Access Compliance Report

Public Rights-of-Way

Intersection ID: 31378	Main Street: CARRINGTON_HILL_DR	Cross Street: AUBREYWOOD_DR	Location: SE
ADA ID: B9570EBA9785	Ramp Type: PerpDiag	Initial Pass/Fail: Fail	Overall Compliance: No
Codes/Mitigation Info/Possible Solution		Field Measurements/Component Compliance	
Severity Score: 33.75

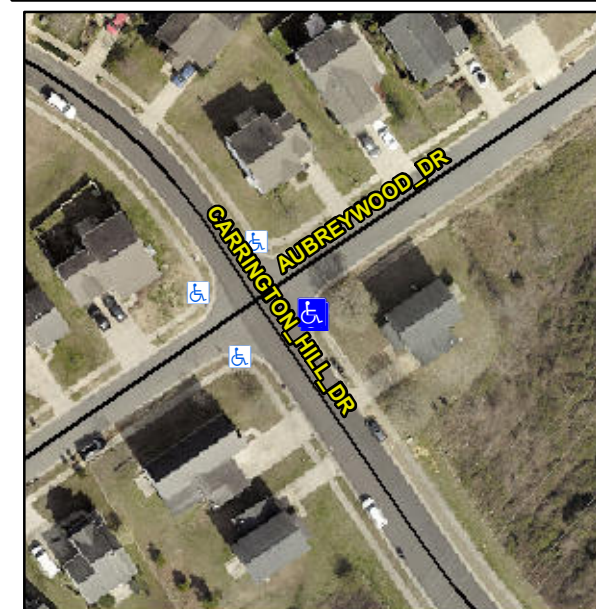
Not Found, R304.5.1, R304.2.2, R304.5.3

Compliance	Description	Data	Compliance	Description	Data
N/A	Ramp Length (in)	51.5	No	Ramp Slope (%)	11.3
No	Ramp Width (in)	40.0	No	Ramp XSlope (%)	6.3
N/A	Flare Type LT	N/A	N/A	Flare Type RT	N/A
N/A	Flare Slope LT (%)	N/A	N/A	Flare Slope RT (%)	N/A
N/A	Flare Traversable LT?	N/A	N/A	Flare Traversable RT?	N/A
N/A	Landing Length (in)	N/A	N/A	DWS Provided?	N/A
N/A	Landing Width (in)	N/A	N/A	DWS Contrast?	N/A
N/A	Landing Slope (%)	N/A	N/A	DWS Length (in)	N/A
N/A	Landing X Slope (%)	N/A	N/A	DWS Full Width?	N/A
N/A	Landing Curb? (Y/N)	N/A	N/A	DWS Offset (in)	N/A
N/A	Shared Landing?	N/A			
N/A	Gutter Ponding?	N/A	N/A	Gutter Slope (%)	N/A
N/A	Gutter Lip Ht (in)	N/A	N/A	Gutter X Slope (%)	N/A
N/A	Painted X Walk1?	No	N/A	Painted X Walk2?	No
	X Walk 1 Direction	To NW		X Walk 2 Direction	To W
N/A	X Walk 1 Width (in)	N/A	N/A	X Walk 2 Width (in)	N/A
	X Walk 1 Slope (%)	4.0		X Walk 2 Slope (%)	6.1
	X Walk 1 X Slope (%)	3.9		X Walk 2 X Slope (%)	6.0

Remove & Replace Curb Ramp With Two New Directional Ramps or Equivalent.
